Shanta Washworks Limited

Plot No. 219,DEPZ (Extension Area), Ganakbari, Ashulia, Dhaka-1349
(23.942745, 90.282229)
3rd March 2021

Observations

Fig: Stress Ratio is <1.05

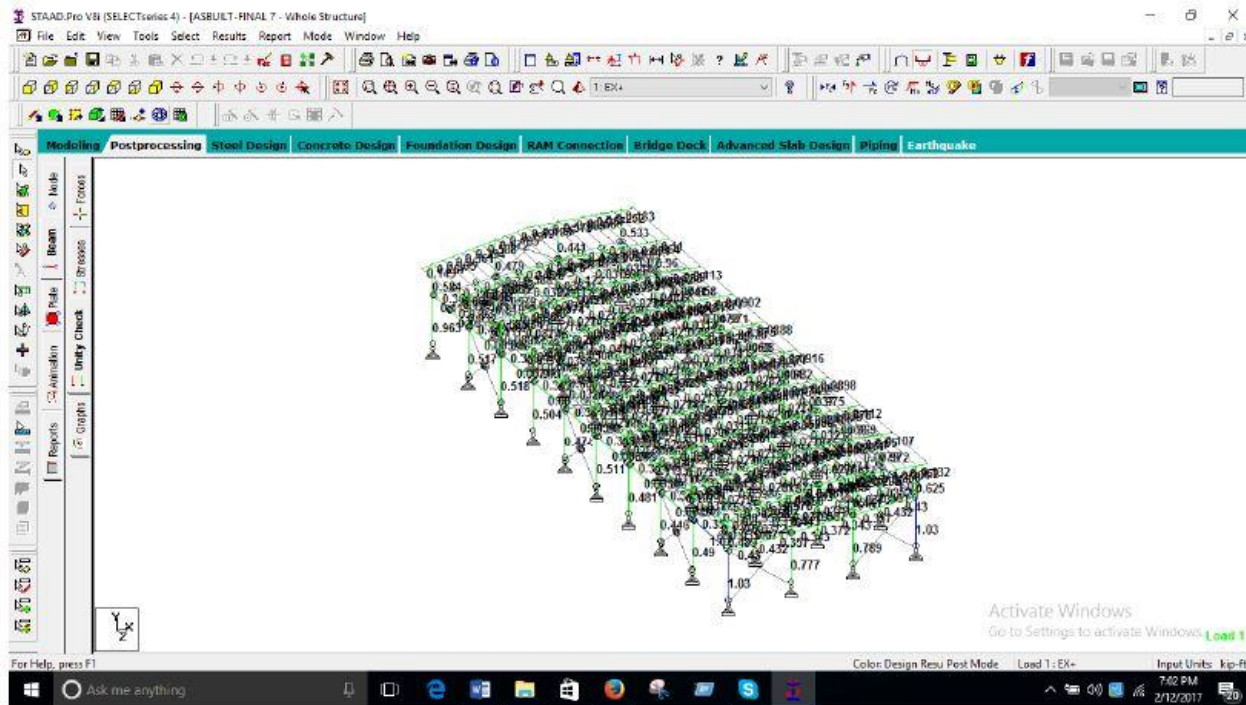
In provided Engineering Assessment (EA) report, only stress ratio of structural members are shown but no displacement and connection adequacy check have been provided. Factory engineer is required to update the prepared EA report.

Missing bracing at first floor Grid 10 (C-D)

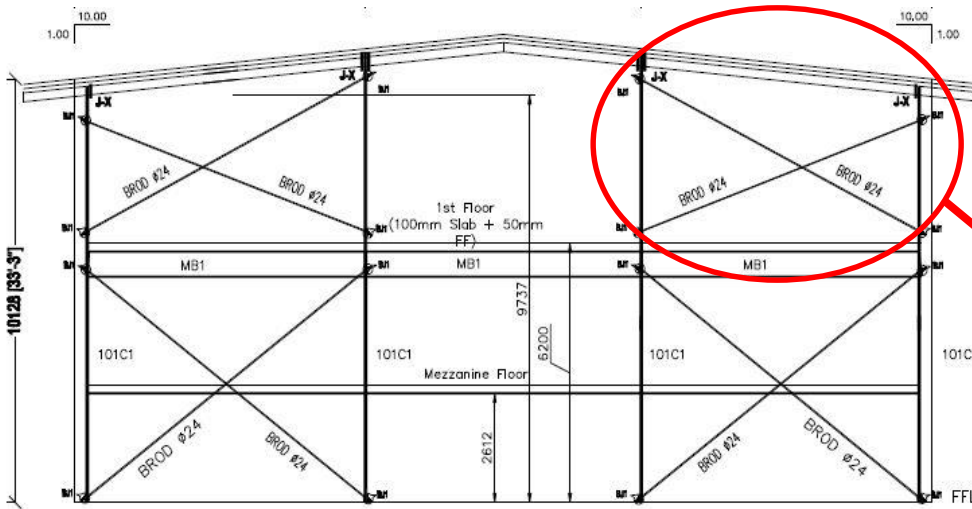
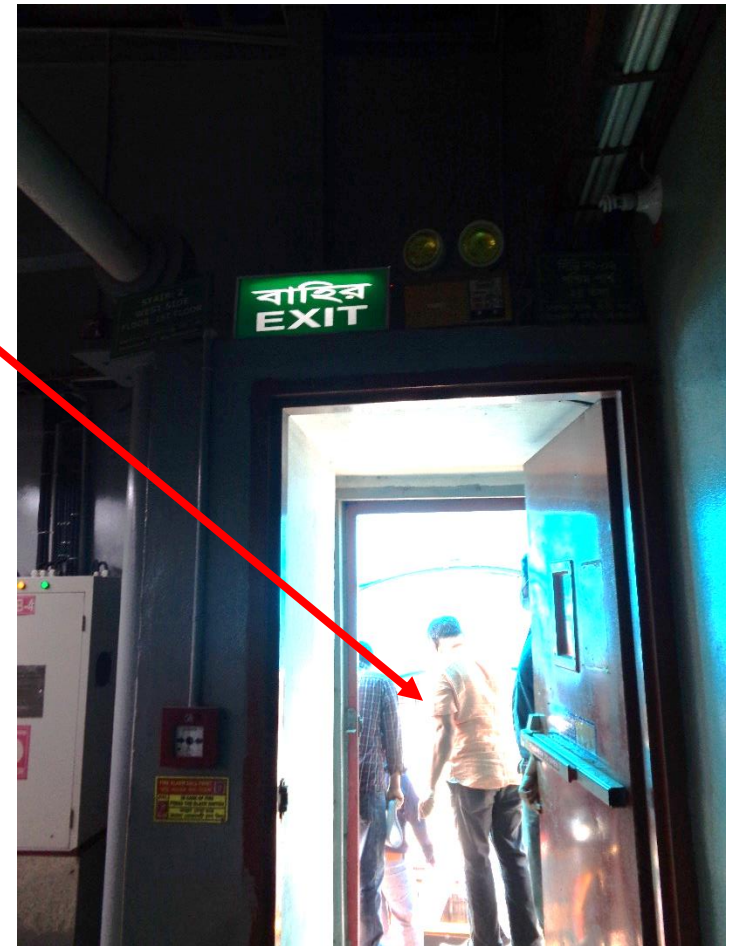
Vertical bracing was missing at first floor north-west corner (along grid-10 and between grid C and D). Factory is required to install the missing bracing as per drawing.

DETAILS OF J-X
 THICKNESS=10 mm
 8-20 mm Ø BOLT
 8-22 mm Ø NUT

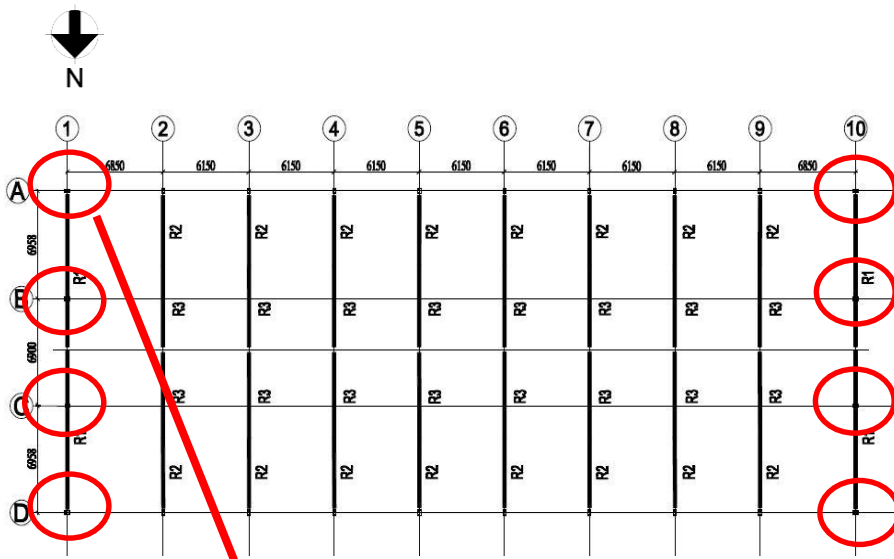
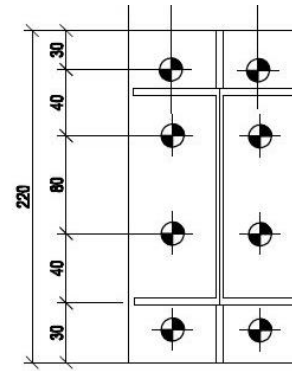
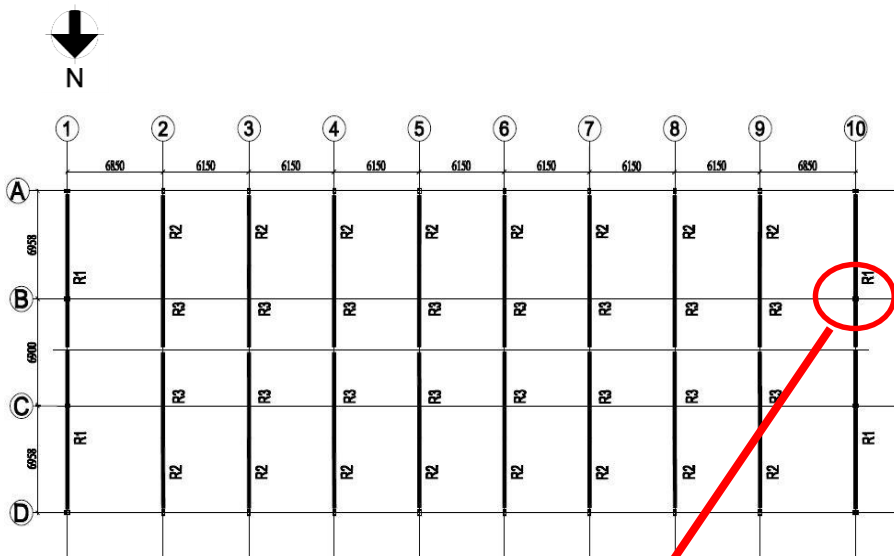
8-No of bolts were shown in the marked locations whereas physically 6-No of bolts were found. Factory engineer is required to survey the whole structure and update the as-built drawing as per onsite condition.

DETAILS OF J-X

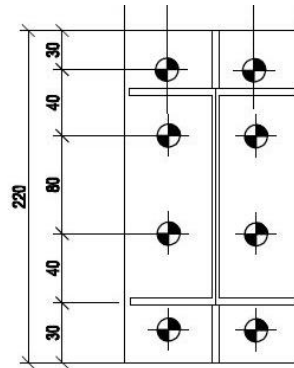
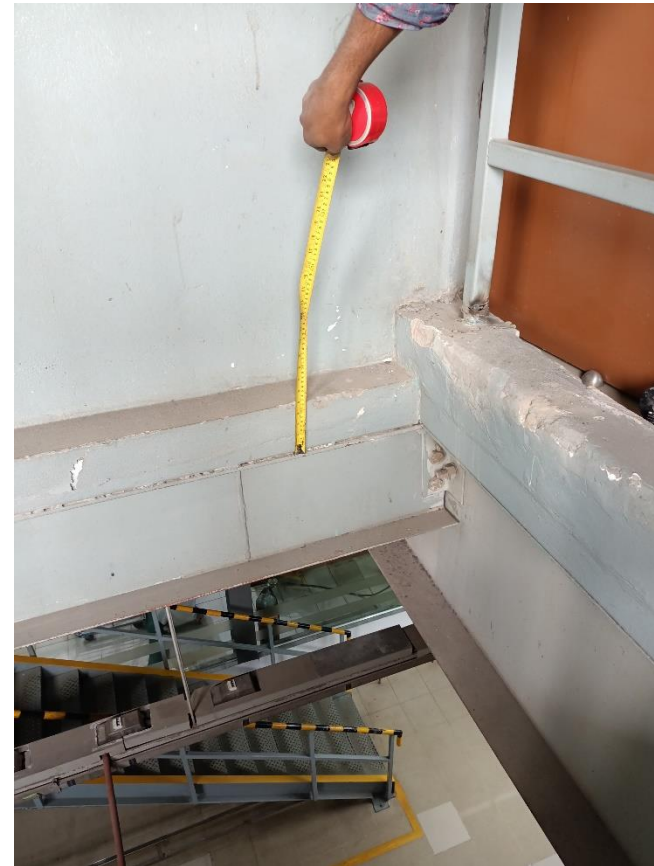
8-20mm diameter bolts were shown in the marked locations whereas physically 6-no of bolts were found which diameter less than shown in drawing (diameter couldn't be measured due to height). Factory engineer is required to survey the whole structure and update the as-built drawing as per onsite condition.

First floor found with steel deck slab

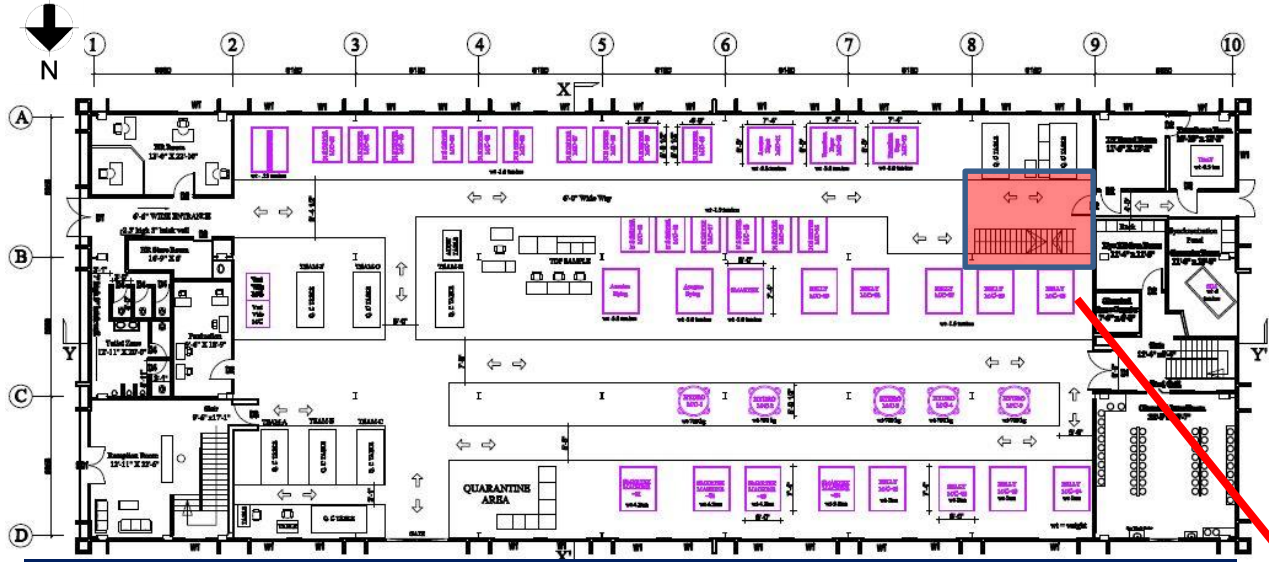
First floor is a steel deck slab with 125mm thickness but no slab detail was shown in provided drawing. Factory engineer is required to update the as-built drawing with onsite condition including the deck slab details.

Steel stair at Ground floor

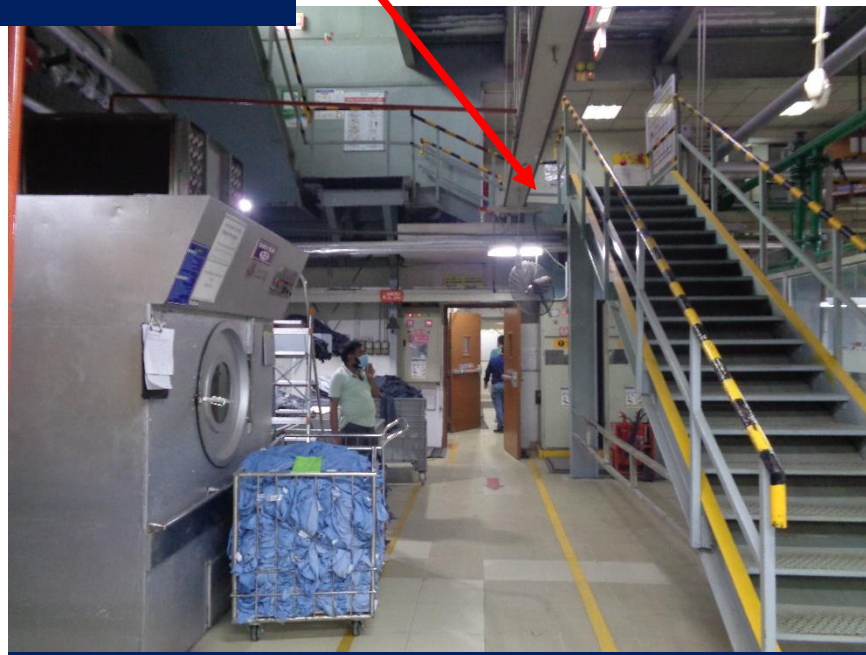
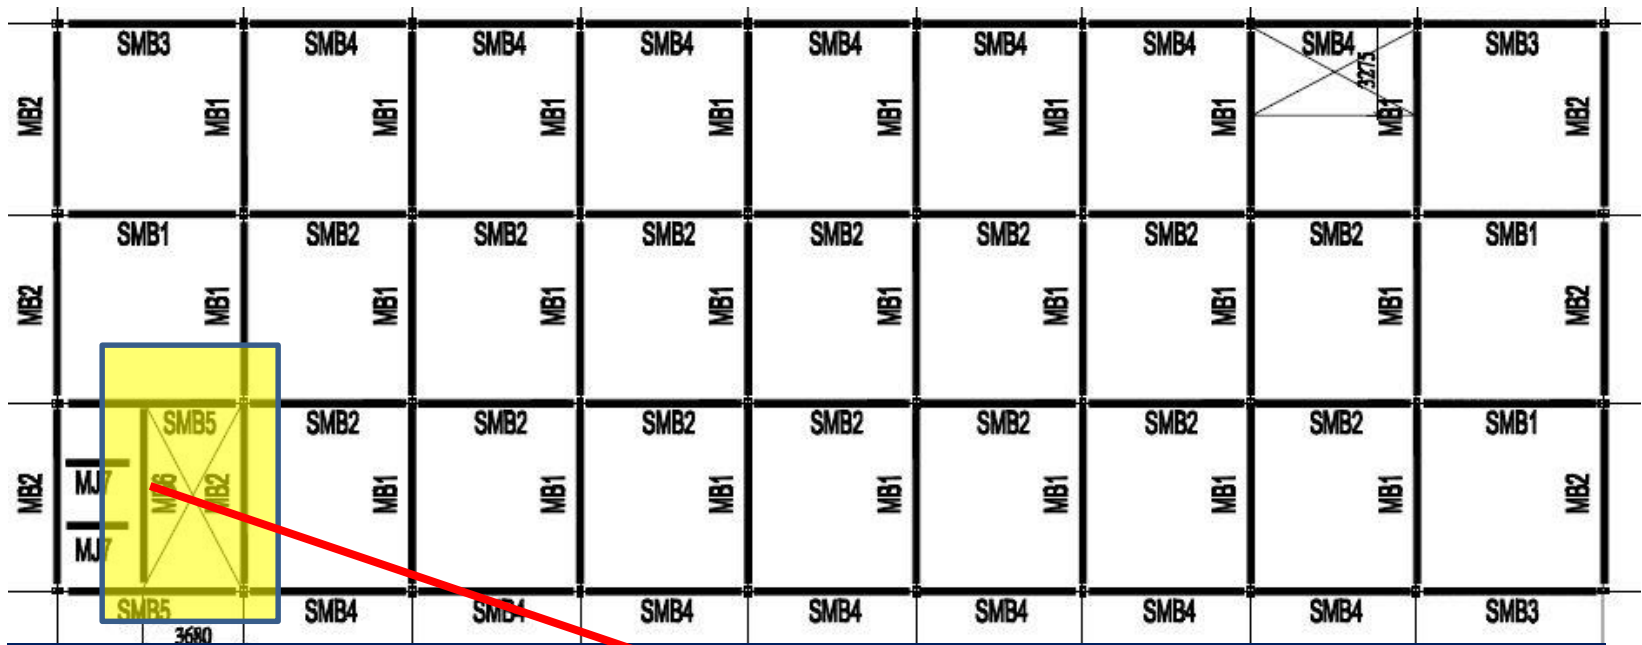
Steel stair with single landing was shown in architectural drawing at Ground floor but no detailing was shown in structural drawing. Factory is required to produce as-built structural drawing for this steel stair.

First floor beam layout

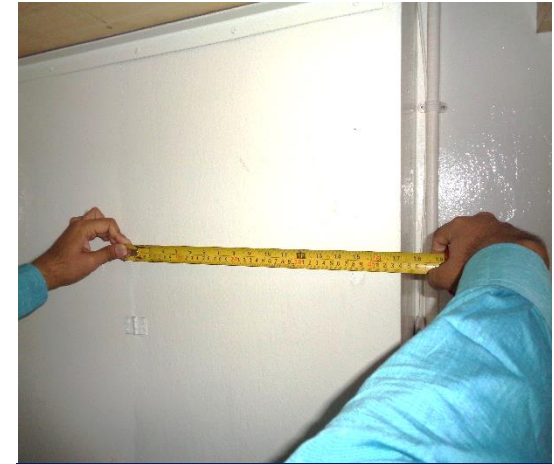
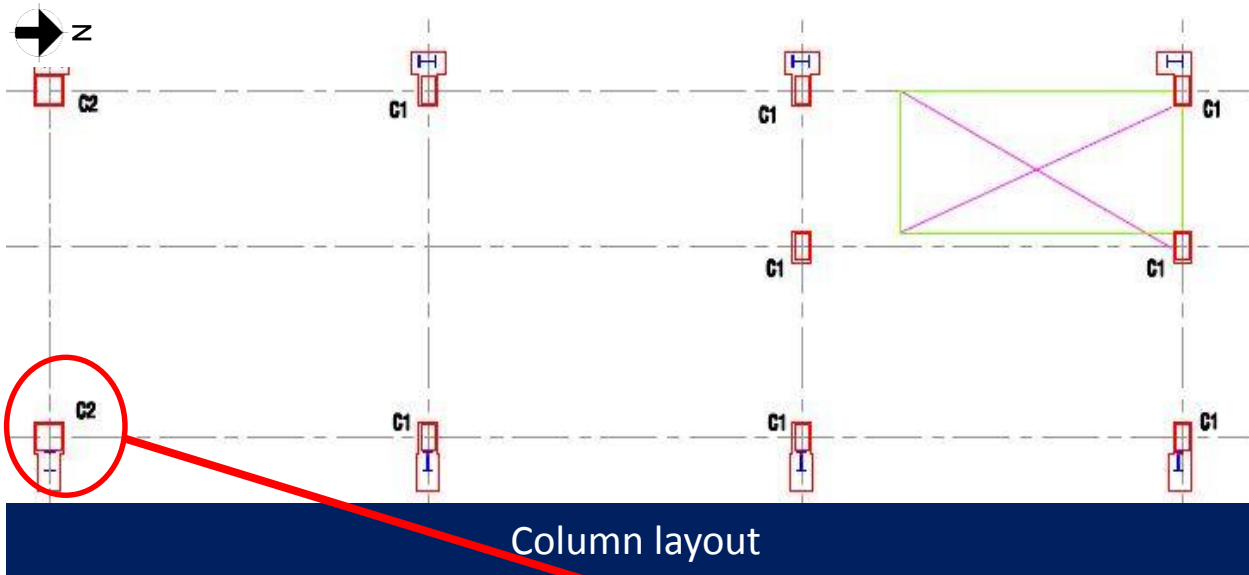
As per provided drawing, Mezzanine part is a RC structure and Main Production Building is a steel structure with deck slab. However, separation of Mezzanine part and Main production Building was not clear. Factory engineer is required to investigate the area and establish separation between the two structures. Otherwise analyze the two structures as a whole.

Column C-2 measured
450mmX450mm

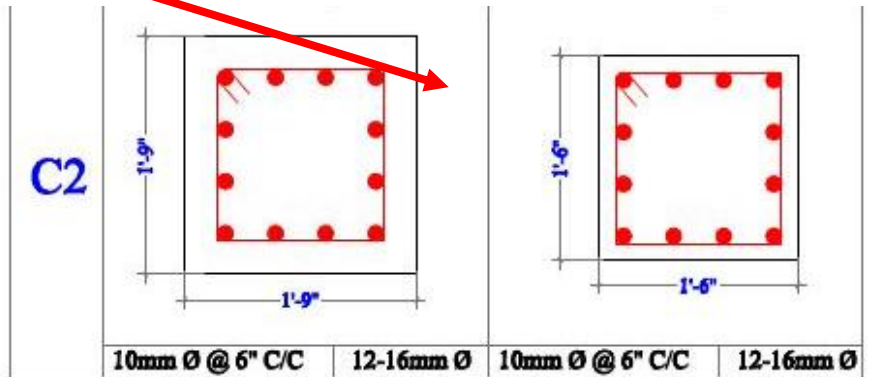
Dimension of column C-2 at highlighted location was measured 400mmX400mm instead of 450mmX450mm. Factory engineer is required to update the as-built drawing with onsite condition.
